# Butte Reduction Works (BRW) Phase III Quality Assurance Project Plan (QAPP) Request for Change BRW-2023-01

RE: Butte Reduction Works (BRW) Phase III Quality Assurance Project Plan (QAPP) Request for Change BRW-2023-01

# **RFC - REQUEST FOR CHANGE**

PHASE III RFC NORTH BRIDGE DESIGN GEOTECHNICAL BOREHOLE LOCATIONS Table 1. Sample Collection, Preservation, and Holding Times

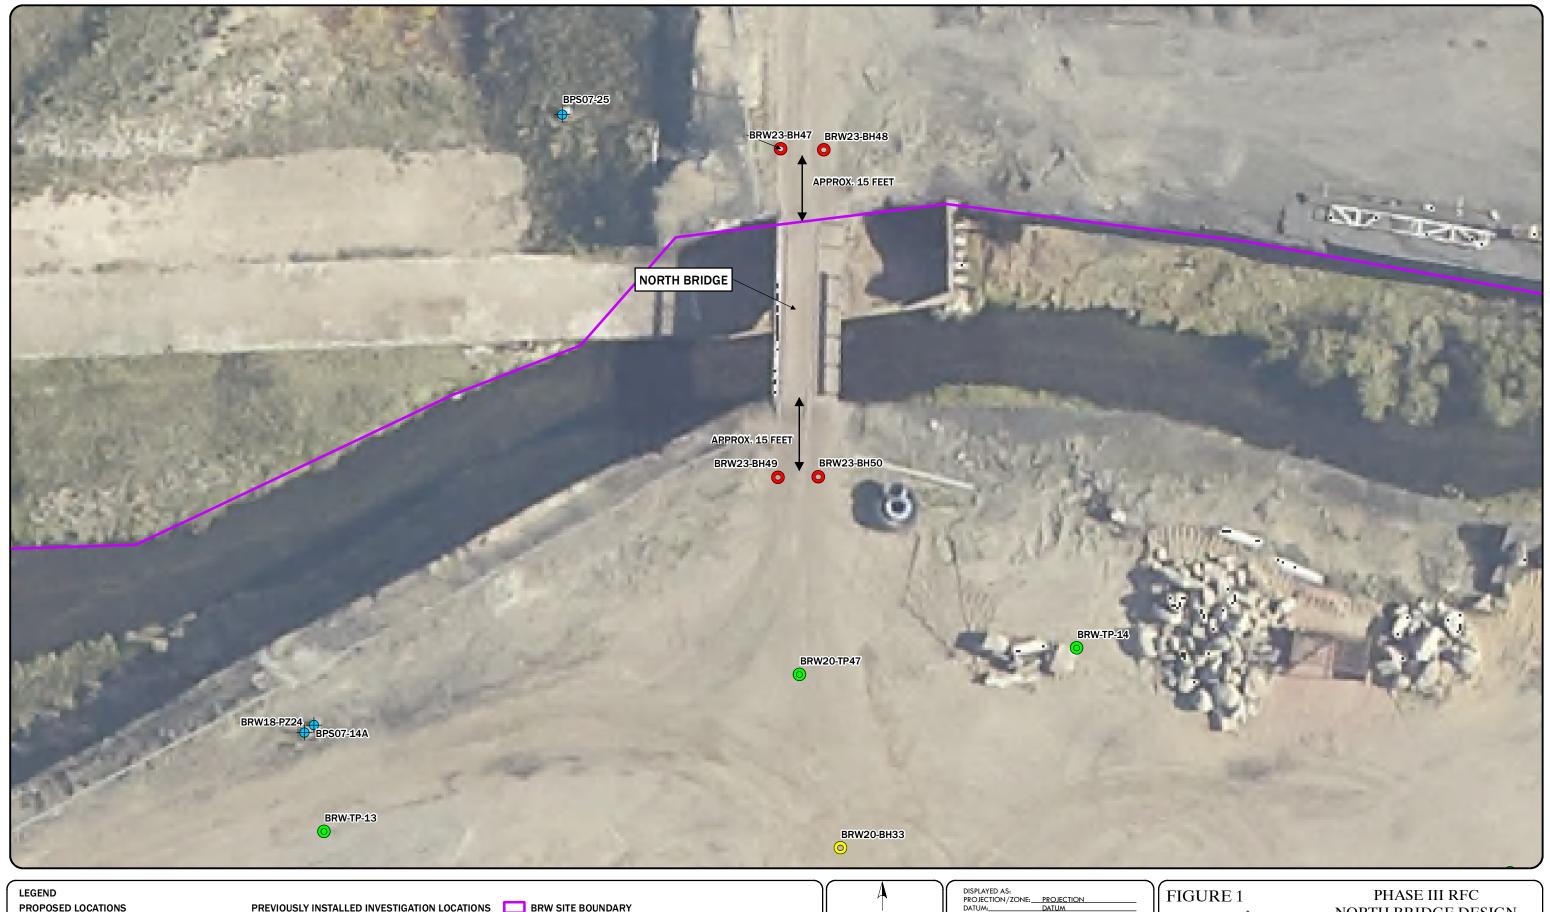
This request for change (RFC) to the Final Butte Reduction Works (BRW) Smelter Area Mine Waste Remediation and Contaminated Groundwater Hydraulic Control Site Phase III Quality Assurance Project Plan (QAPP) (Atlantic Richfield Company, 2022) (Phase III QAPP) provides the procedures and protocols necessary for Atlantic Richfield Company (Atlantic Richfield) to install additional boreholes and collect additional geotechnical data to meet a data quality objective specified in the Phase III QAPP and provide the necessary information to support design and construction of the proposed bridge replacement (North Bridge) that will span the Silver Bow Creek channel on the north side of the site (Figure 1).

One of the data quality objectives within the Phase III QAPP is to help determine the geotechnical details of the site to ensure adequate soil stability around potential structural features. While previous investigations have collected data related to the soil lithologies and presence of slag near the existing bridge, a geotechnical investigation focused on evaluating the physical properties of the soil and slag has not been completed near the North Bridge (Figure 1).

Based on field conditions and recommendations from the geotechnical engineer, an appropriate drill rig will be used to complete field testing and collect sample solids for laboratory analysis. The following general procedures will be performed at each borehole location (Figure 1). Note that this list is not intended to be a complete list.

The locations shown in Figure 1 are approximate and the number and location of the boreholes may be modified as determined by the Field Team Leader and/or CPM in consultation with the Contractor QAO.
